UNITED STATES PATENT AND TRADEMARK OFFICE

APPLICATION NO.	FILING DATE	FIRST NAMED INVENTOR	ATTORNEY DOCKET NO.	CONFIRMATION NO.
10/814,840	03/31/2004	Douglas R. Woellner	200313398-1	6491
22879	7590	09/28/2005	EXAMINER	
HEWLETT PACKARD COMPANY P O BOX 272400, 3404 E. HARMONY ROAD INTELLECTUAL PROPERTY ADMINISTRATION FORT COLLINS, CO 80527-2400			NGUYEN, TRUC T	
			ART UNIT	PAPER NUMBER
			2833

Office Action Summary

DETAILED ACTION

FIG. 1

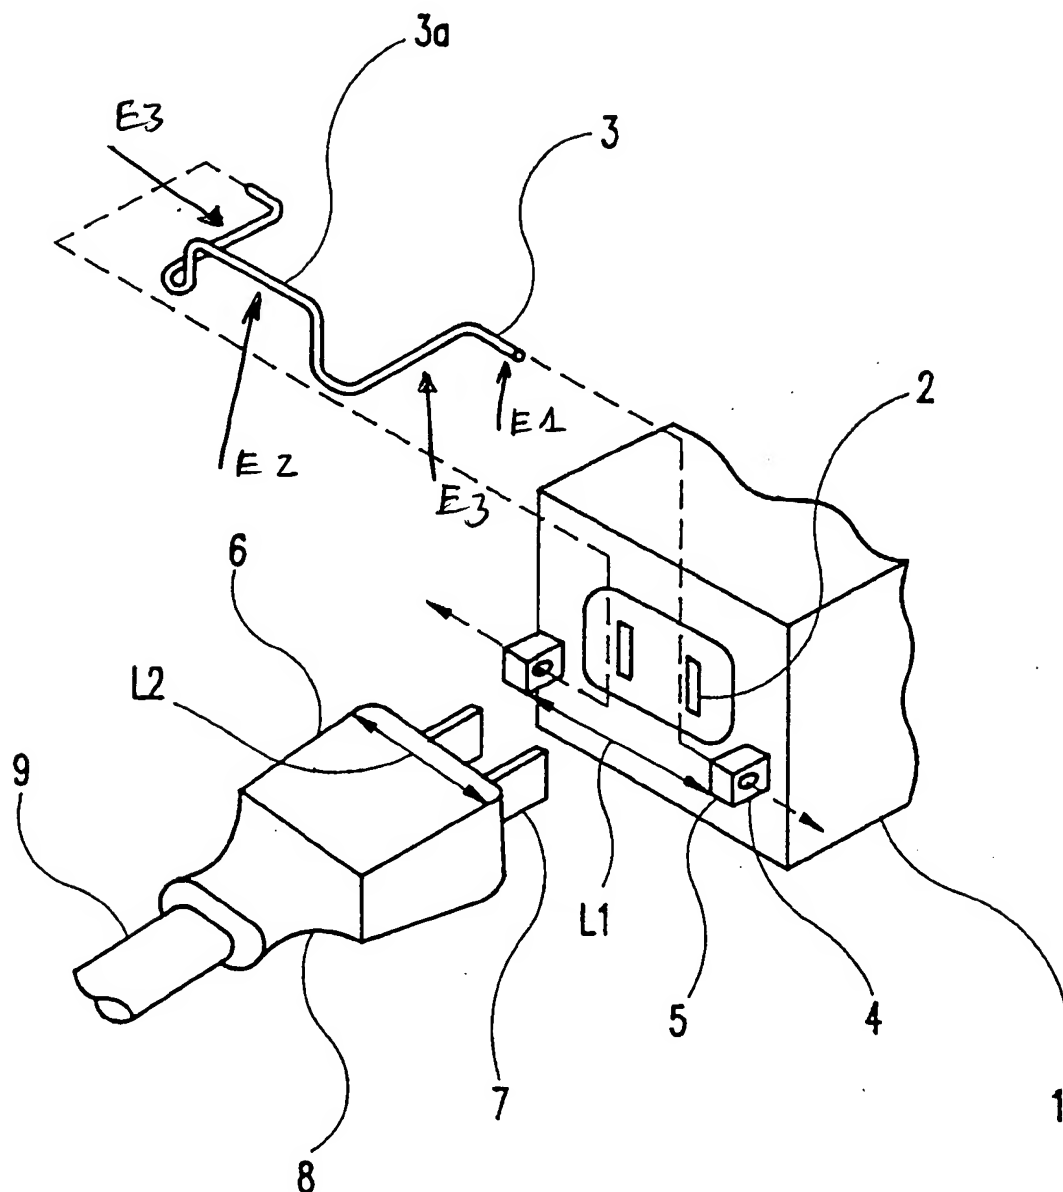
Shibuya et al. disclose:

a circuitry housing (1) having a slot (hole in member 4, Figure 1);

a cable plug (6) having a lip (8);

a U-shaped clip body (3), comprising:

a first retention (E2, Examiner's attachment) engages the lip;

a second retention (E1) engages the slot.
